DESCRIPTIVE REPORT

Type of Survey ... Hydrographic.....
Field No. RA-20-3-87.....
Registry No. H-10249.....

State Alaska.....
General Locality .. Togiak Bay.....
Sublocality Head of Togiak Bay.....

Descriptive Report to Accompany Hydrographic Survey H-10249

ATTACHMENT A

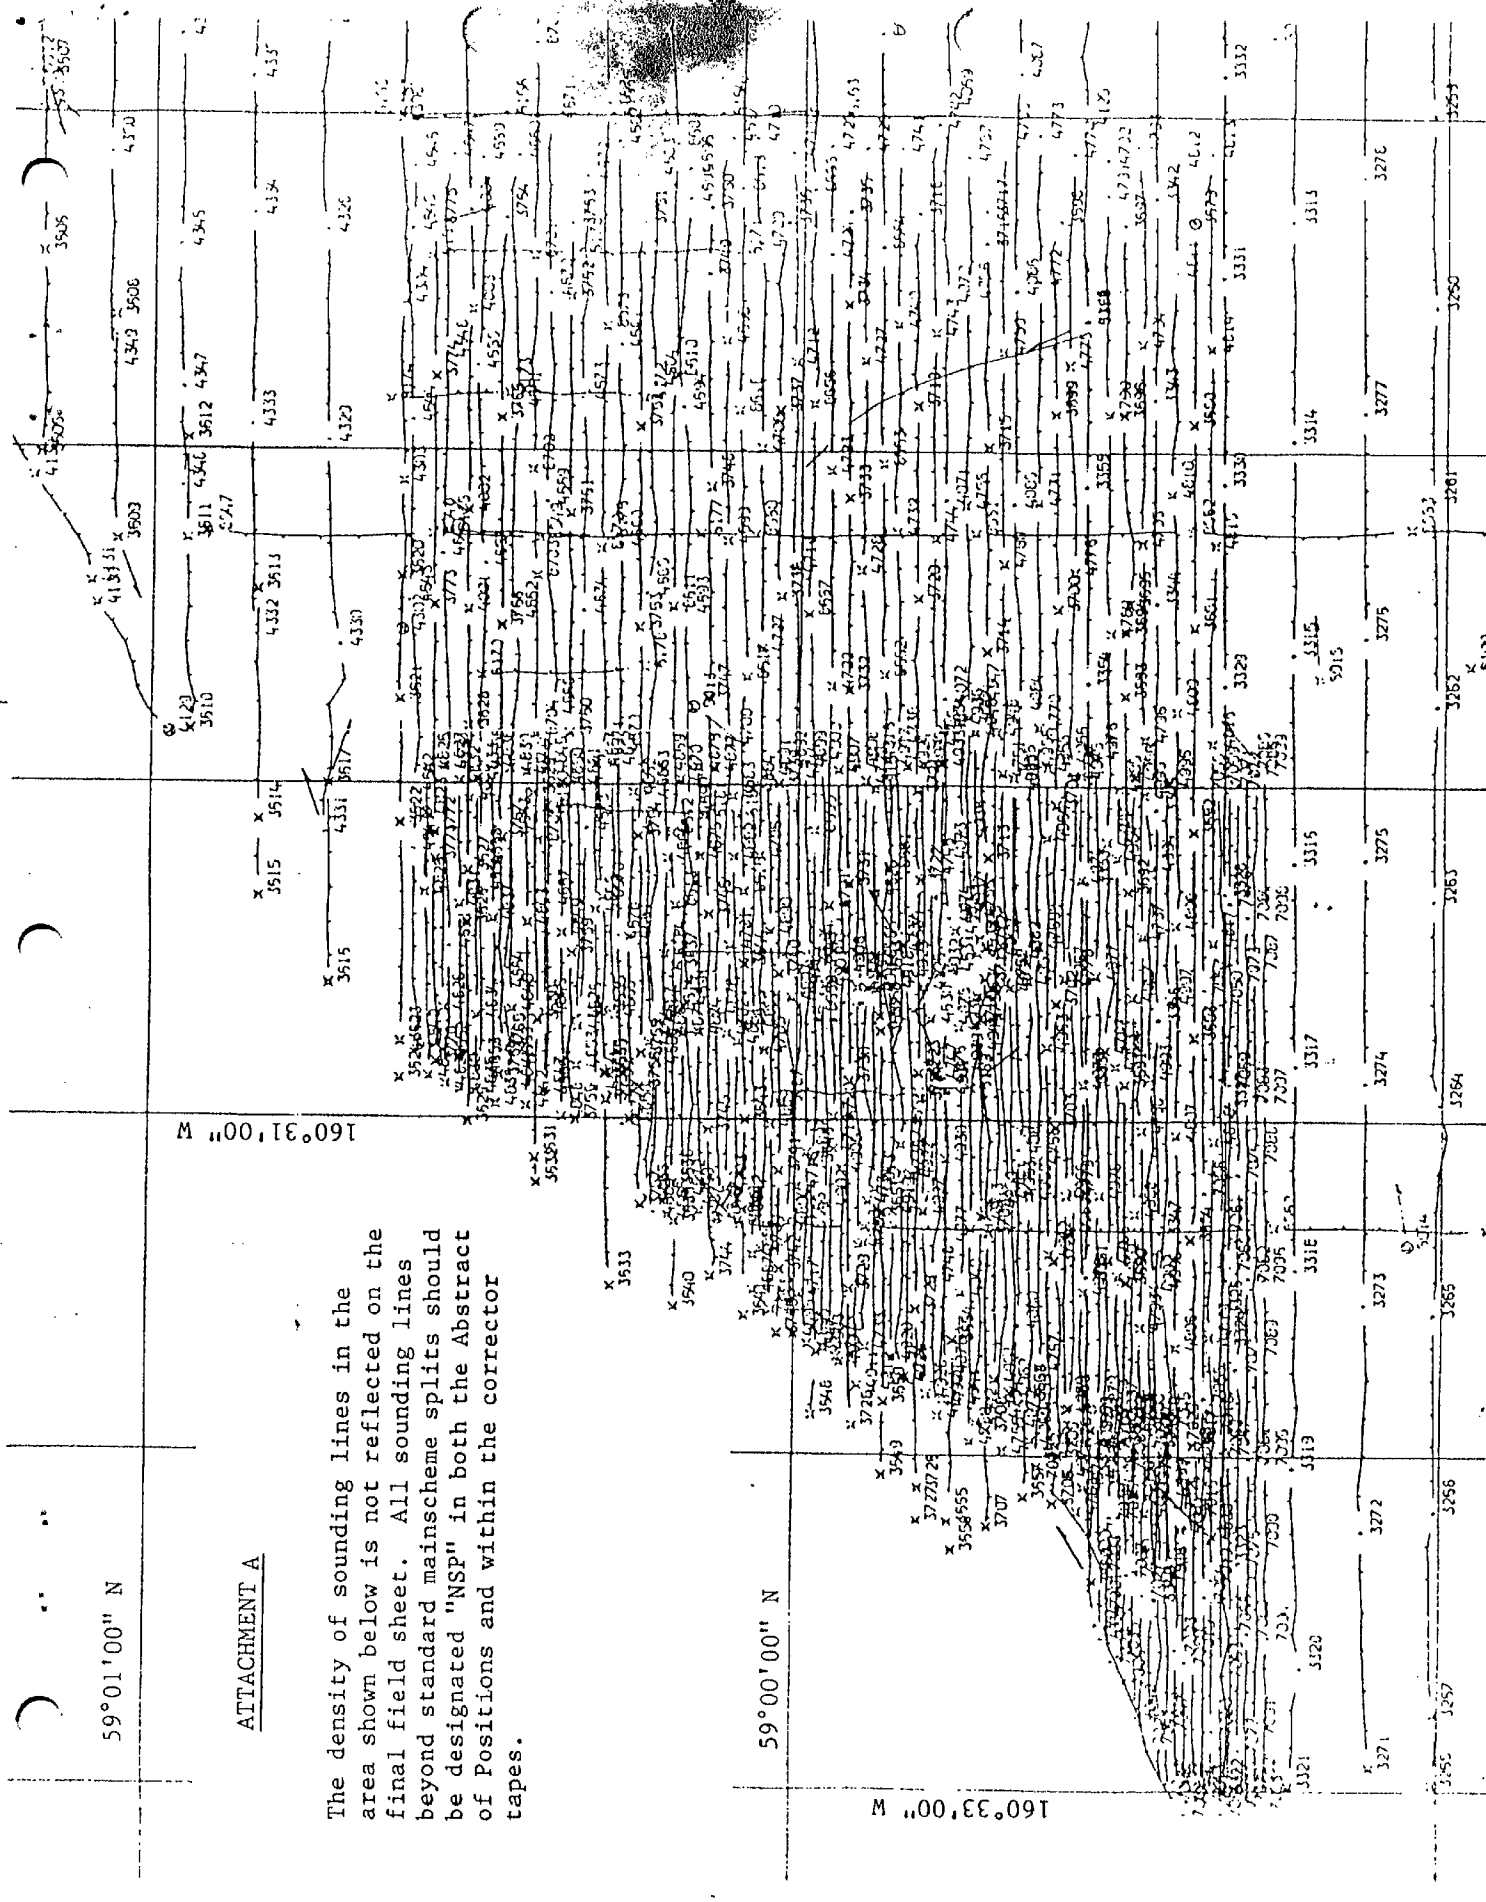
The density of sounding lines in the area shown below is not reflected on the final field sheet. All sounding lines beyond standard mainscheme splits should be designated "NSP" in both the Abstract of Positions and within the corrector tapes.
